## MEMORANDUM

**To:** Planning Board  
**FROM:** Sloane Walbert, Case Manager  
**DATE:** August 17, 2015  
**SUBJECT:** **Call Up Item:** Approval of a Minor Amendment to Approved Site Review to convert six one-bedroom units into a new community center at 3502 Nottingham Ct. (Kalmia Apartments), which includes the addition of 588 square feet on two levels. Included in the approval are new porches and decks on all ten buildings, new storage sheds for all units, updated landscaping and a relocated playground. In addition, the drive access between Nottingham Ct. and Arthur Ct. will be converted into a one-way pedestrian-oriented street. The project site is zoned Residential – High 4 (RH-4). Case No. LUR2015-00023.

# BHP - Kalmia

SHEET NAME  
**L-101**

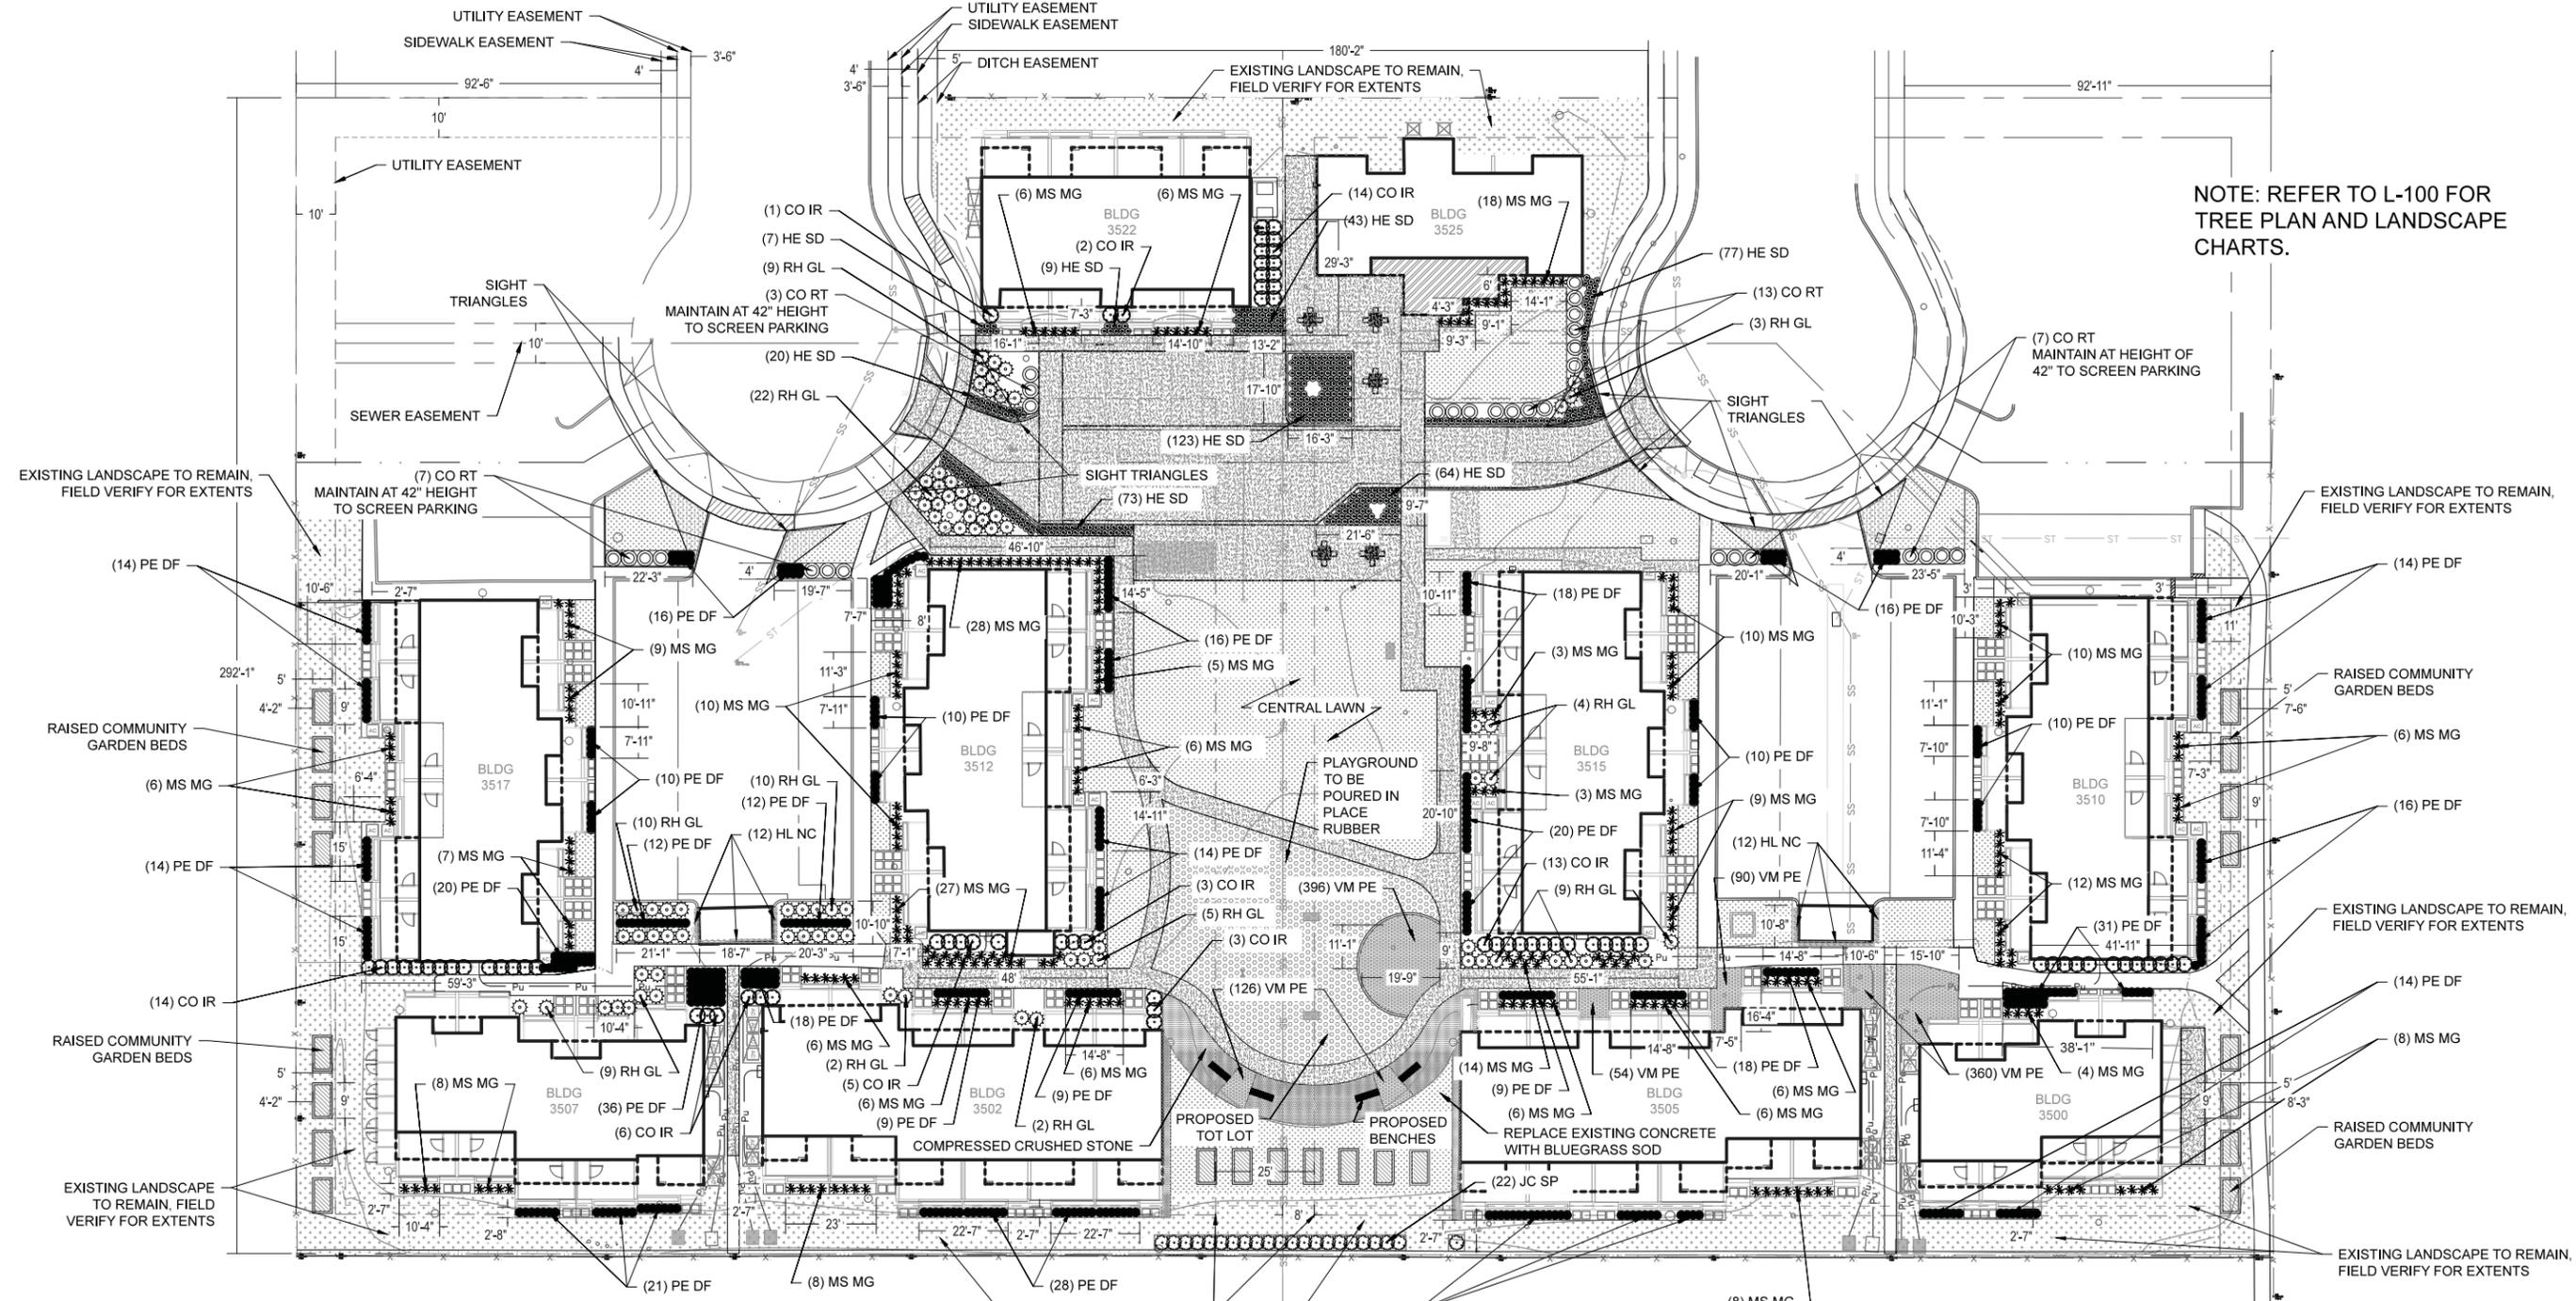
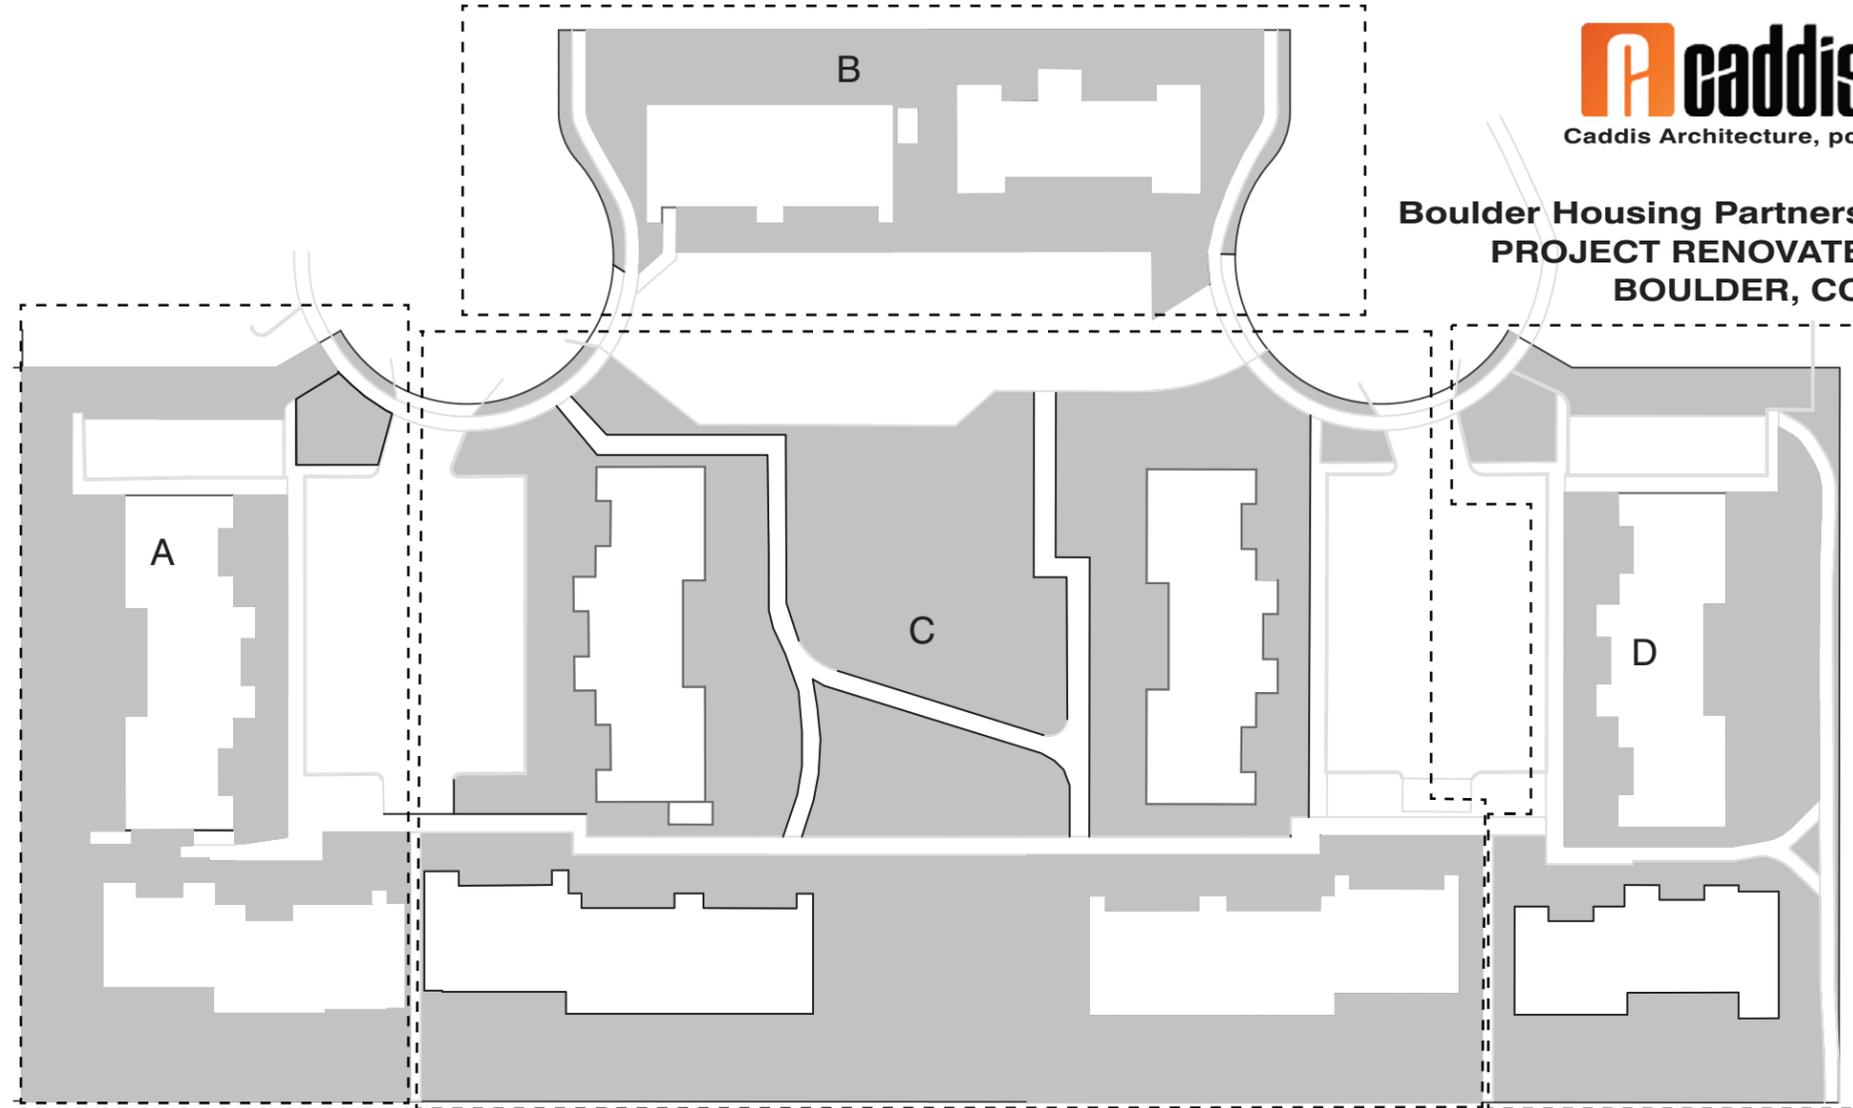
1. Please revise the plans to describe and show how long-term bicycle parking and short-term bicycle parking will be met on the site. Per [table 9-8](#) of the land use code, two bicycle parking spaces are required per unit (98 spaces total). Twenty five percent (24 spaces) must be short-term parking and seventy five percent must be long-term parking (74 spaces). Refer to [section 9-9-6\(g\)](#), B.R.C. 1981 for bicycle parking standards for long-term and short-term bicycle parking. Staff recommends providing some long-term bike storage in the form of vertical racks on rear decks (see attached). In addition, please include a table on the site plans showing the number of short-term and long-term bicycle parking spaces that are required and the number of spaces provided.

8. Please revise the landscape plan to:

- Remove the installation of pavers within the City's public right-of-way; and
- Show the site's proposed sidewalk connecting to the back of the existing street sidewalk, rather than to the back of the street curb.

**Response:** Long term bicycle parking will be provided at each unit private shed with two provided hooks. There will be 96 long term spaces & 8 short term spaces provided. Short term bicycle parking will be provided by bike loops or similar method near the community mail kiosk.
2. Please revise the site plans to show the design details of the proposed "collective covered bike shelter" and the number of bikes that can be accommodated by the shelter.

**Response:** The landscape plan has been updated to reflect the corrections above.

**Response:** A landscape requirements table has been included, see sheet L101.

2 PRELIMINARY UTILITY PLAN  
SCALE: 1" = 20'

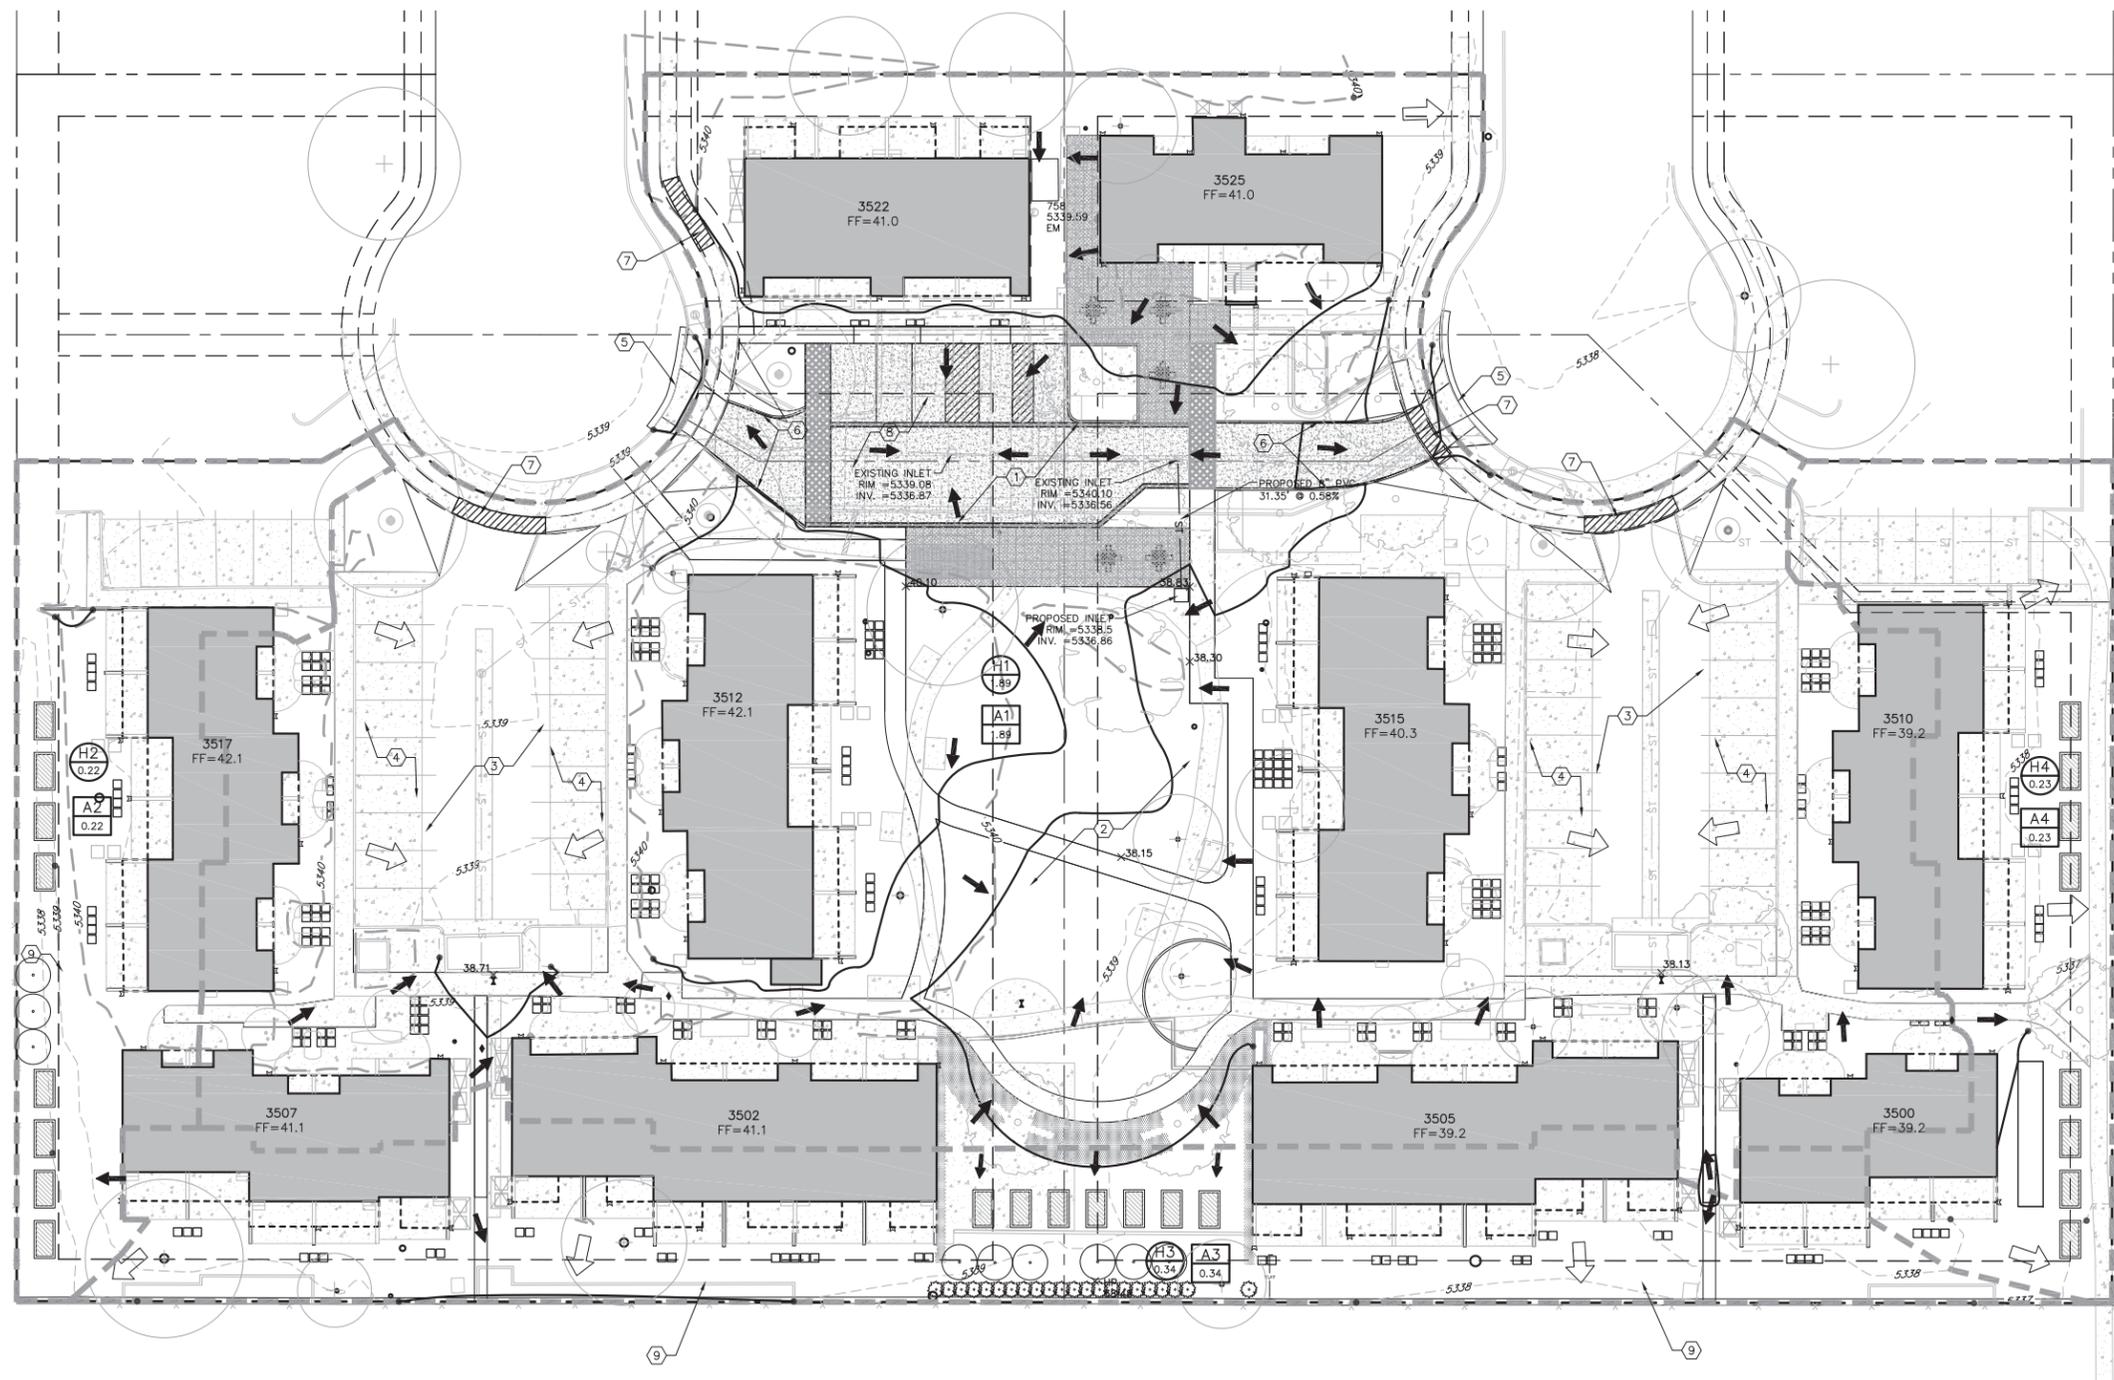
1. *The Preliminary Utility Plan (Sheet C-102) shows the proposed irrigation service line running parallel to the wastewater main directly on the edge of the easement (½ of the water meter would be in the easement and ½ would be outside the easement) and under a proposed new bus shelter. Service lines in easements may not run parallel to main lines in easements or right-of-way. Relocation of the irrigation line and meter is required.*
